**ADDENDUM NO. 1**

December 10, 2020

**THE CITY OF GREENVILLE NC  
FIRE RESCUE NO. 1 BAY EXPANSION  
500 S GREENE ST, GREENVILLE, NC 27834  
ARCHITECTS PROJECT NO. 1667**

**ABD-1**

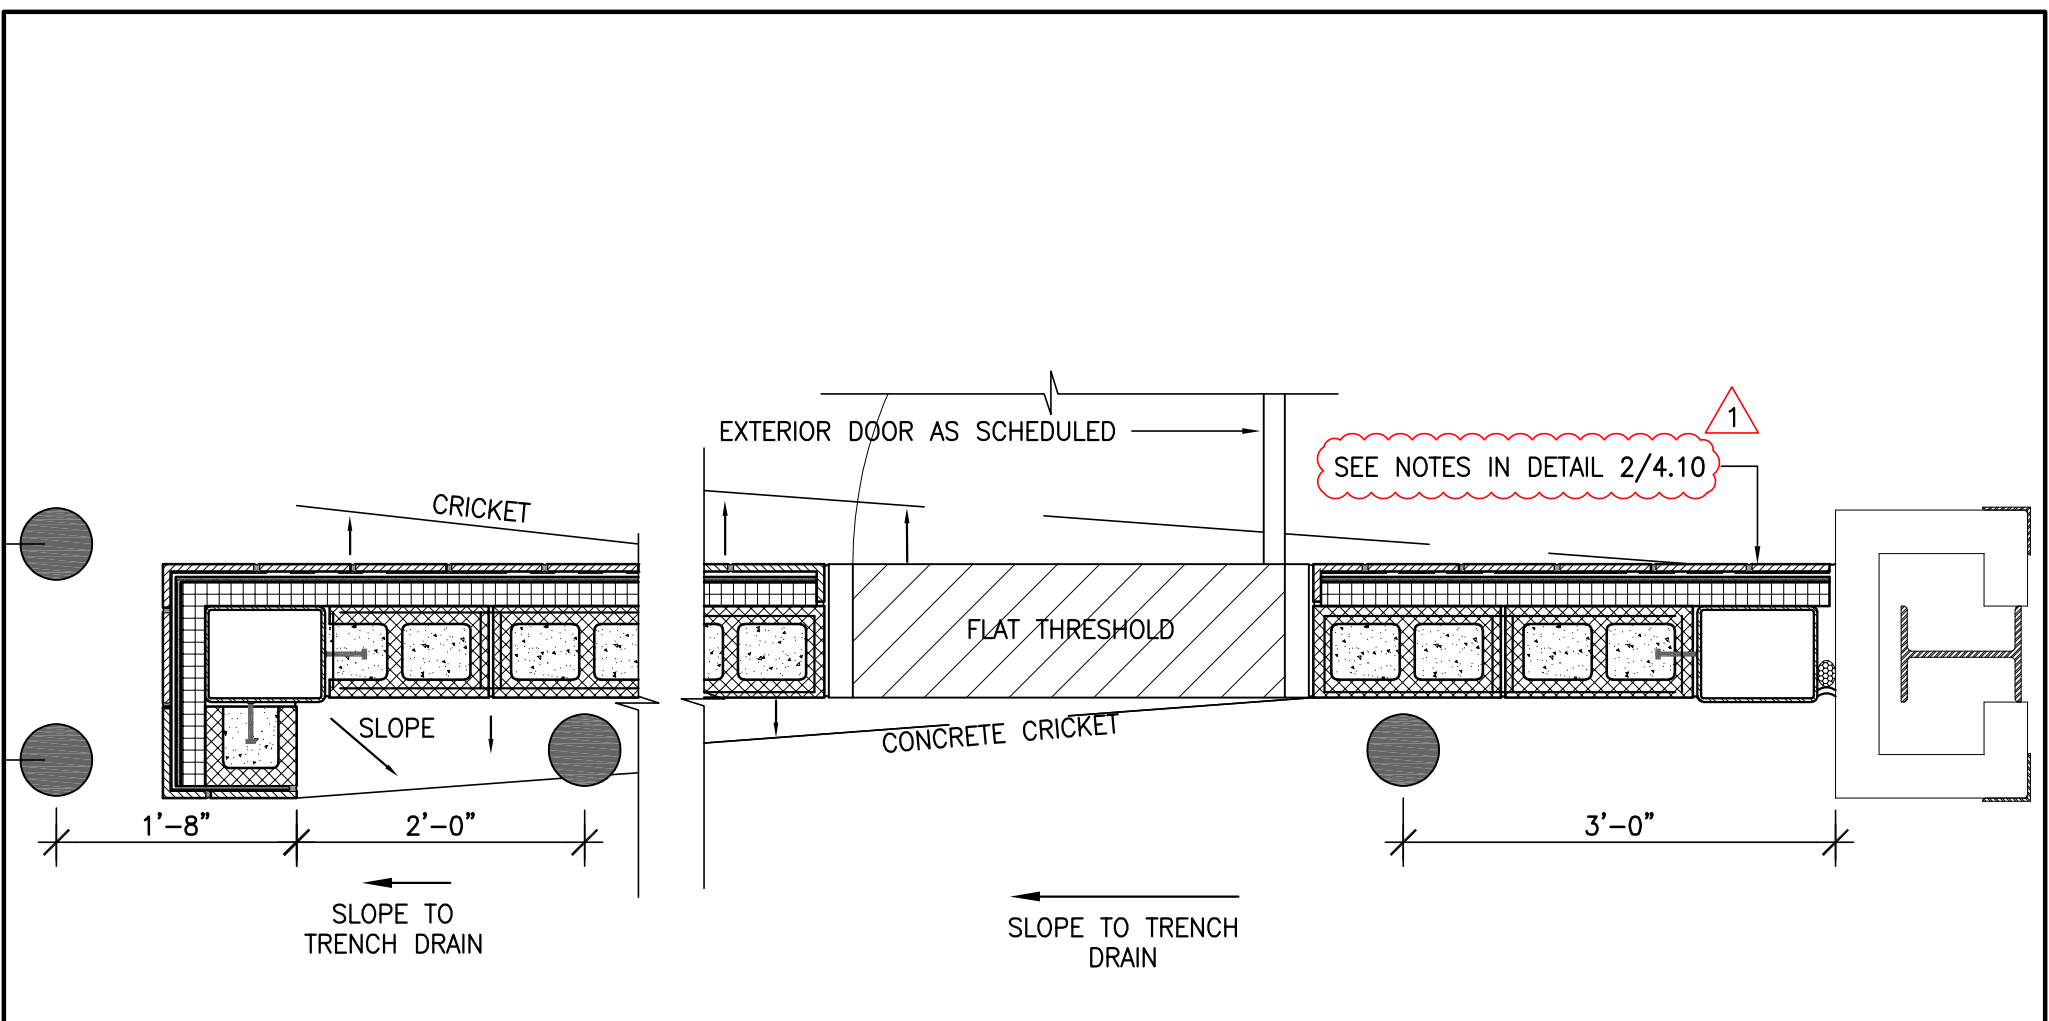
**General Note:** All exposed expansion joint material at floor to be held down ½” from top of slab for joint sealant (see attached **ABD-1**).

**ABD-2**

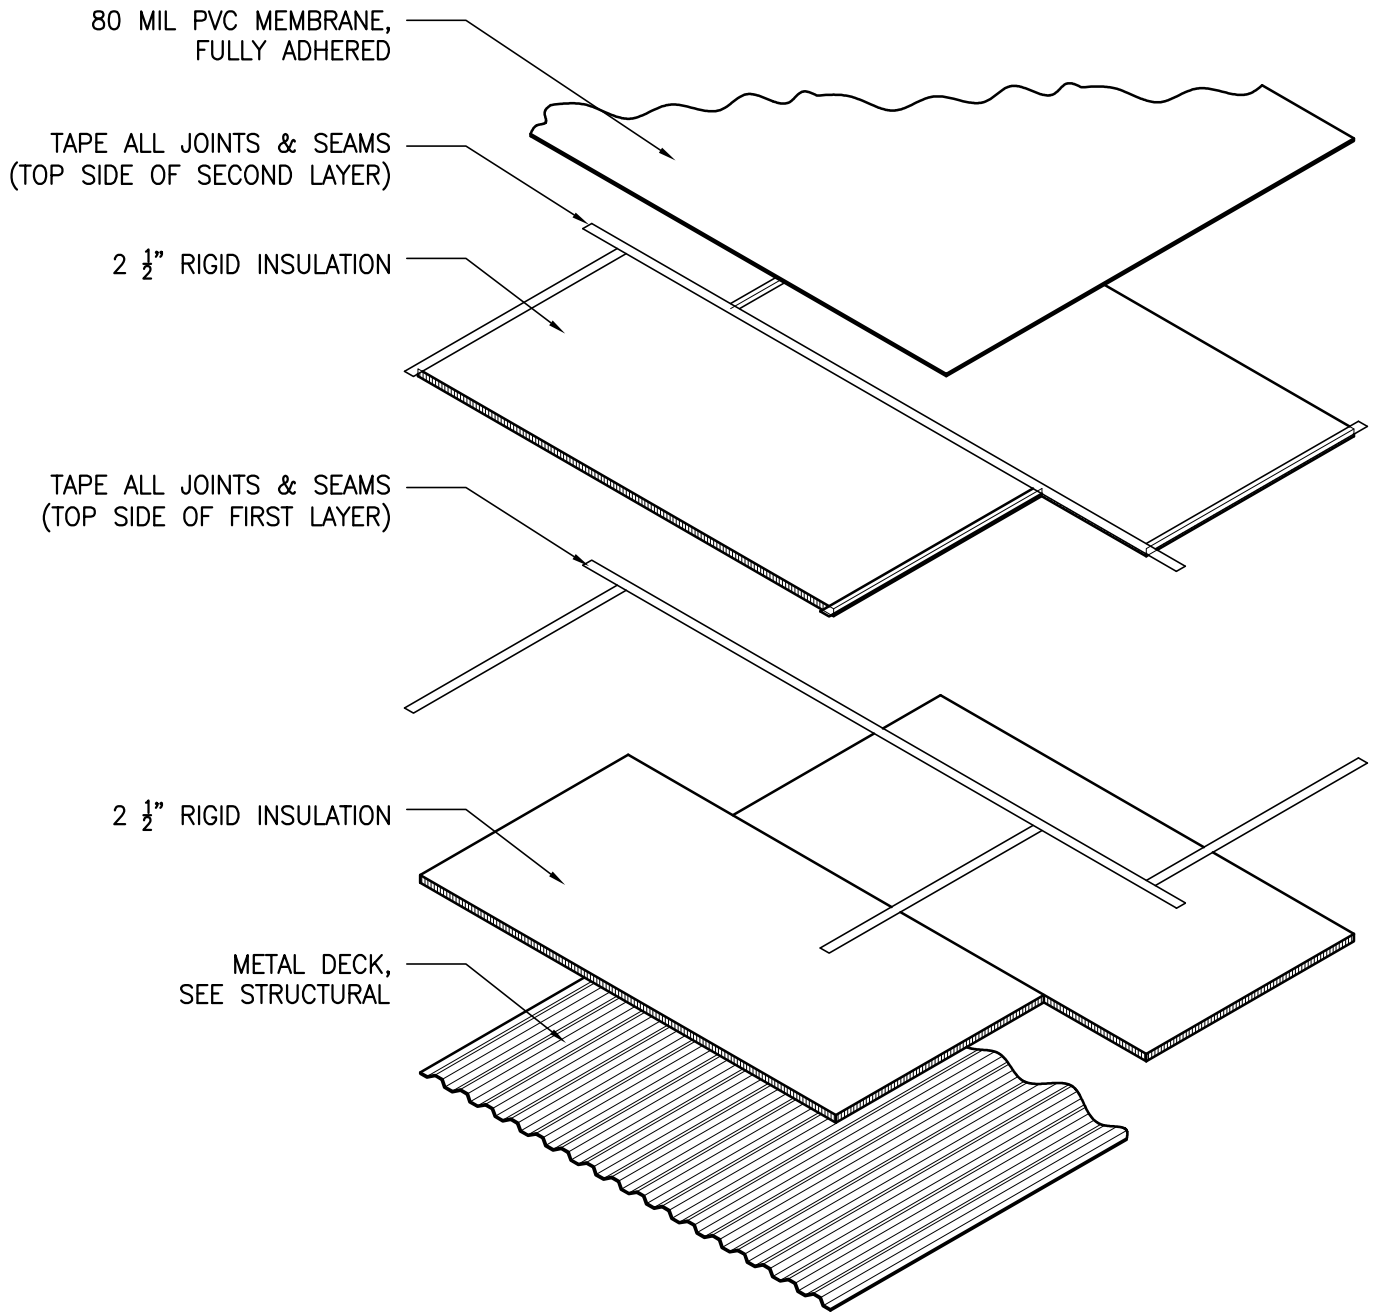
- C-1** Updated Index of Drawings (Architectural) and changed Alternate Storage/Staging Location to **604 S Clark St, Greenville NC 27834** instead of 600 S Pitt St, Greenville, NC 27834 (see attached revised sheet C-1 and replace the previous sheet).
- 4.10** Detail 5/4.10, Revised note for clarification to reference **Detail 2/4.10** instead of Note 2/4.10 (see attached **ABD-2**).

**REFERENCE SHEET NO. 4.10**  
 NOTE REVISED FOR CLARIFICATION

**ABD-3**

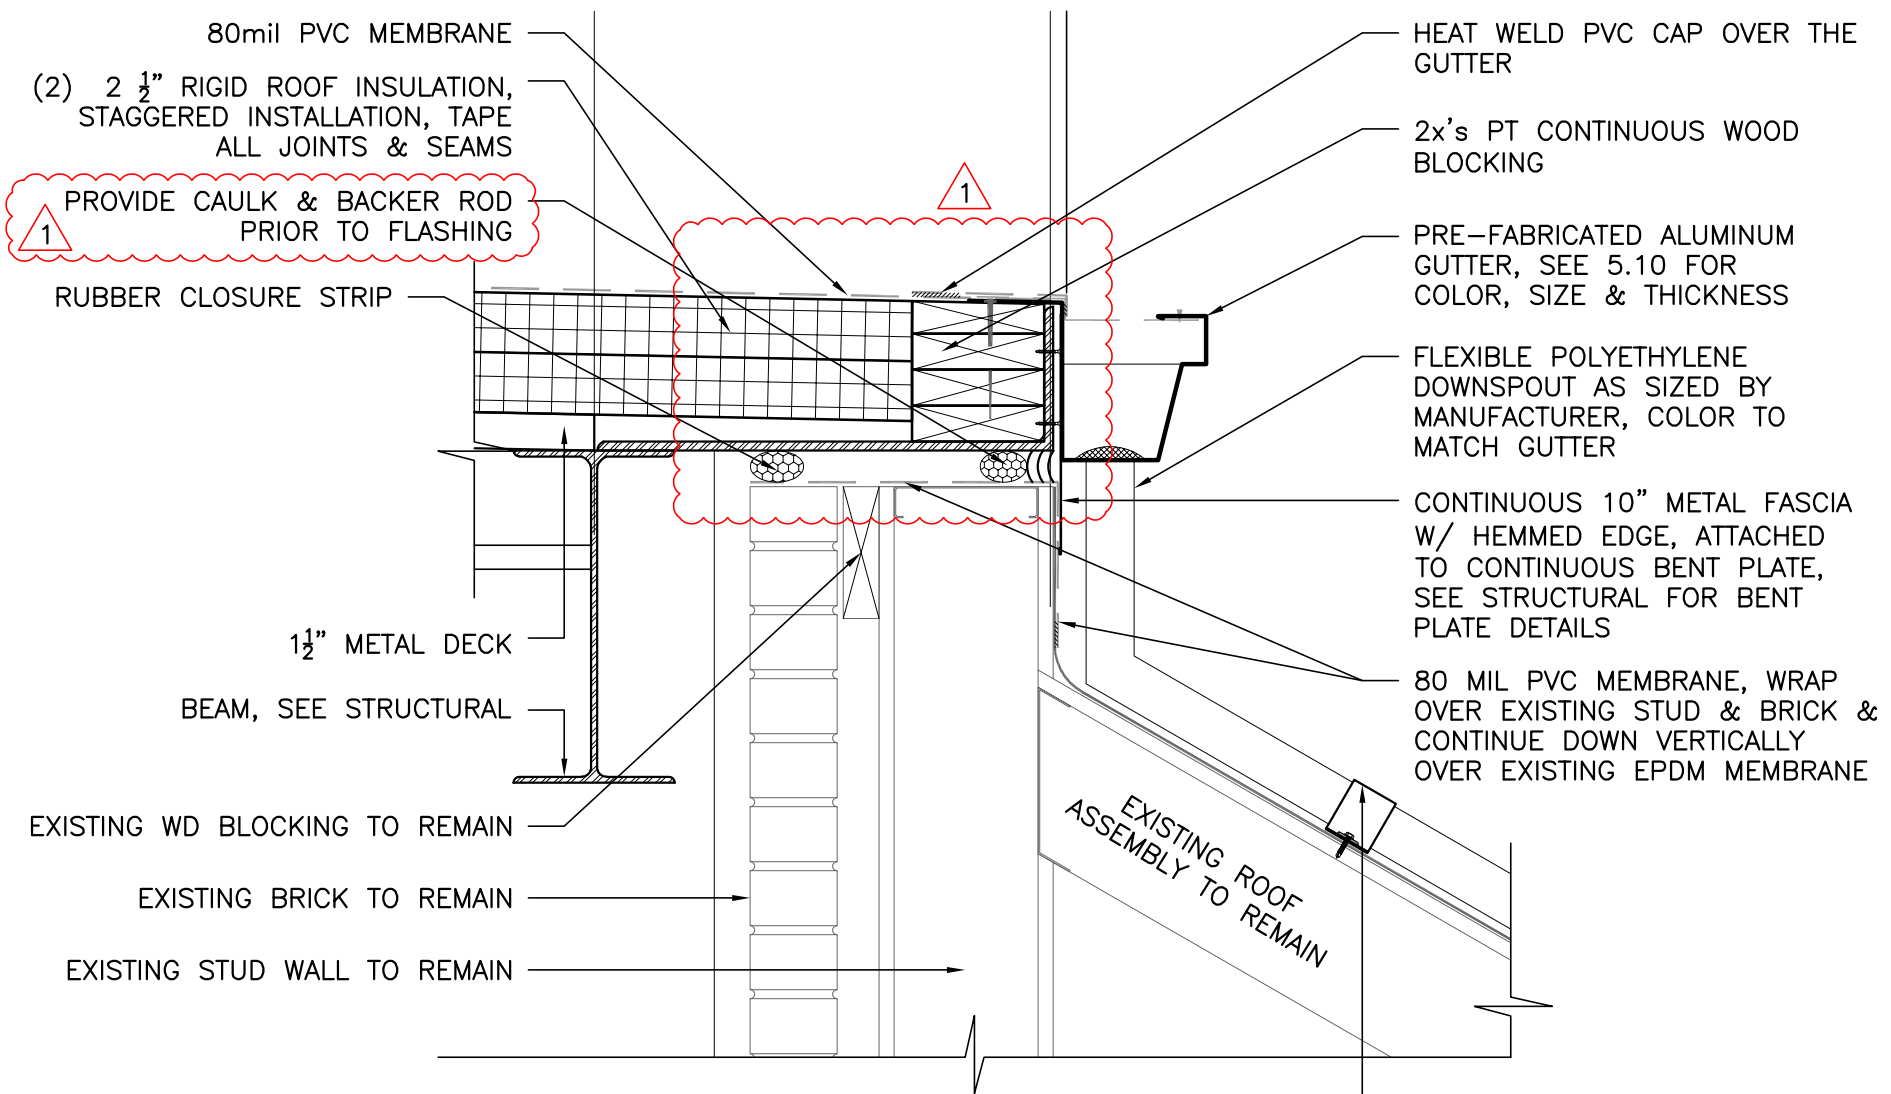
CLOSURE STRIPS SHALL BE REMOVED.  
WOOD BLOCKING GENERAL NOTE ADDED.

CANTS TO BE SIZED TO AVOID STANDING WATER.

**ABD-4**

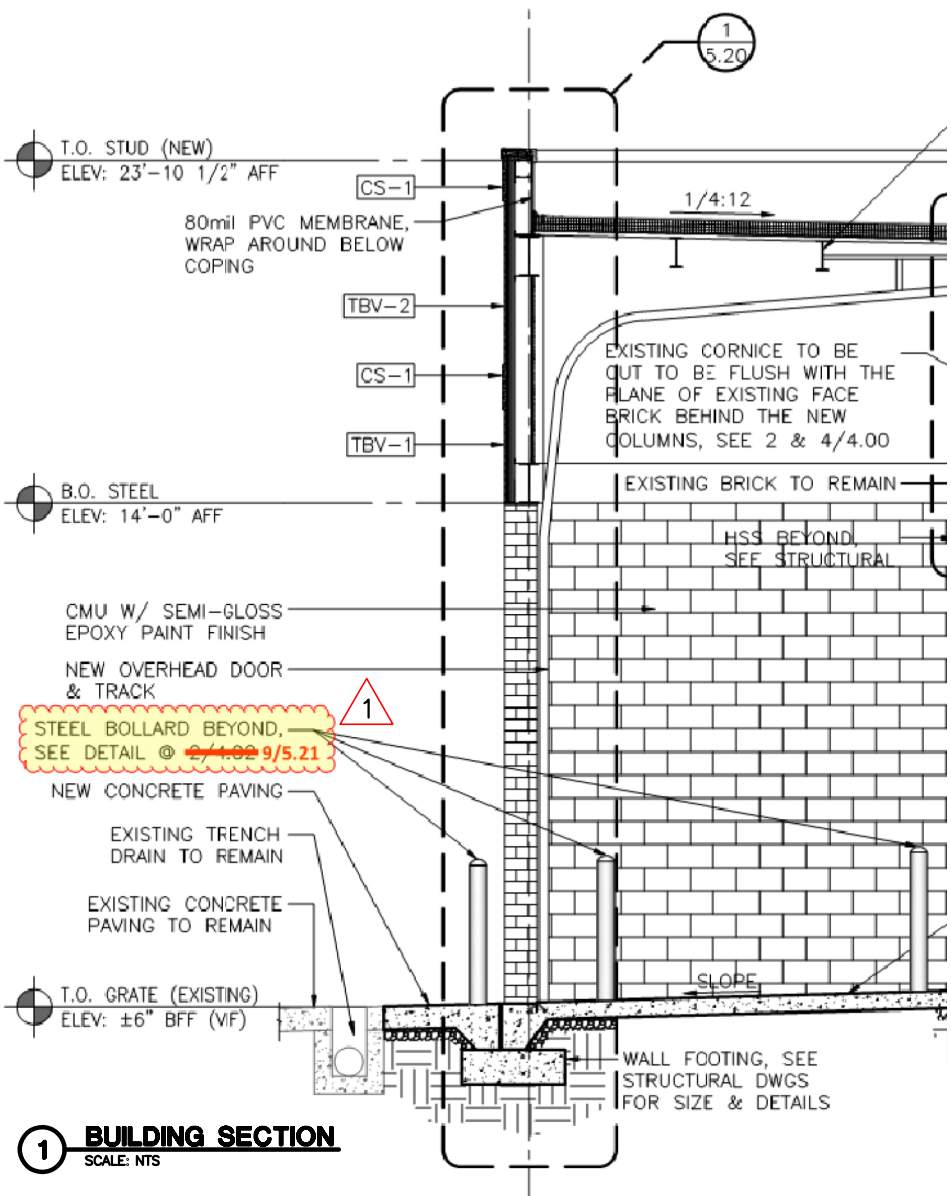
**REFERENCE SHEET NO. 4.12**  
**REVISED ROOF DETAIL AT TRANSITION**

**ABD-5**

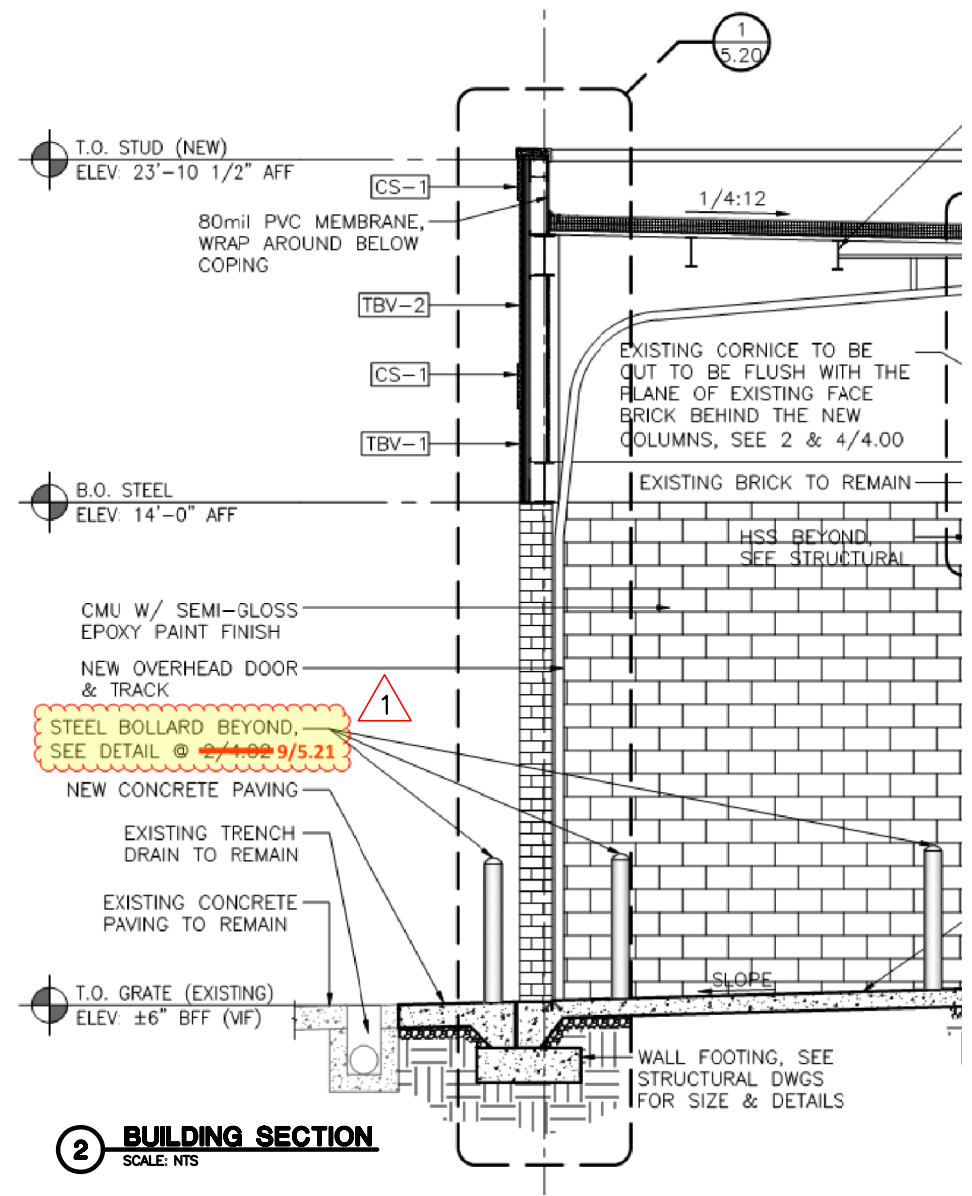
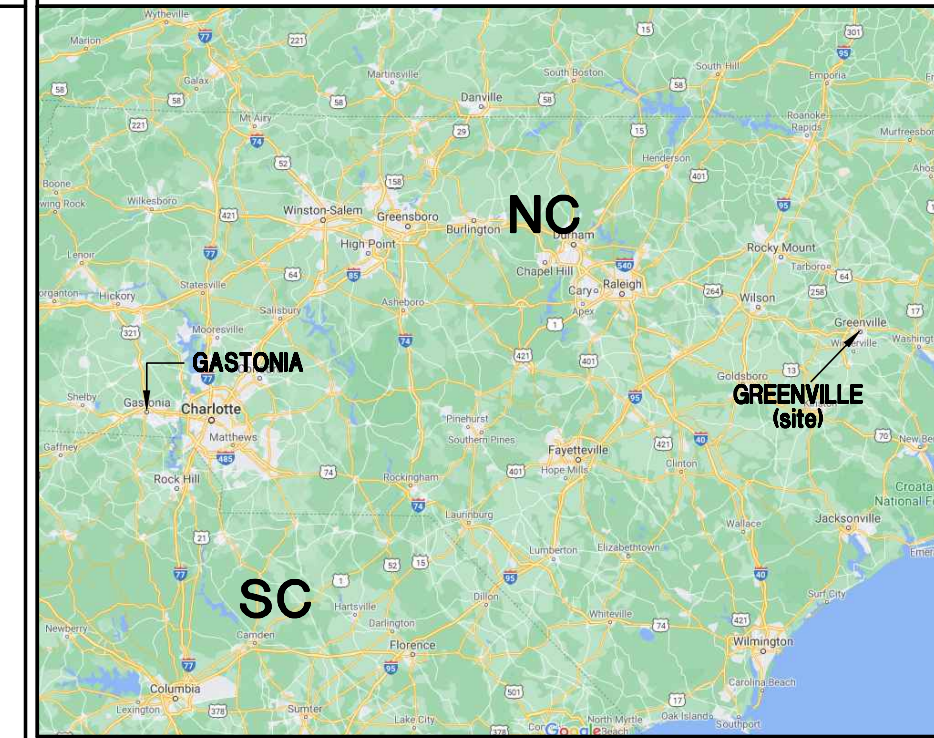
- 4.11** See clouded items on revised drawing which includes changes to: Detail 1/4.11 - Door Type D2, HM Door Specs, Hardware, Detail 2/4.11 - Elevation tag location & Detail 3/4.11 - Finish Plan Alternates (see attached revised sheet 4.11 and replace the previous sheet).
- 4.12** Detail 2/4.12 - Closure strips shall be removed and Add under Wood Blocking General Notes: CANTS TO BE SIZED TO AVOID STANDING WATER (see attached **ABD-3**).
- 4.12** Detail 5/4.12, Revised Roof Detail at Transition (see attached **ABD-4**).
- 5.10** Corrected Drawing Scales & Elevation Tag and added new Emergency Light (see attached revised sheet 5.10 and replace the previous sheet).
- 5.11** Detail 1/5.11 & 2/5.11, Bollard detail callout shall be **9/5.21** (see attached **ABD-5**).

REFERENCE SHEET NO. 5.11  
REVISED NOTE ON 1/5.11 & 2/5.11
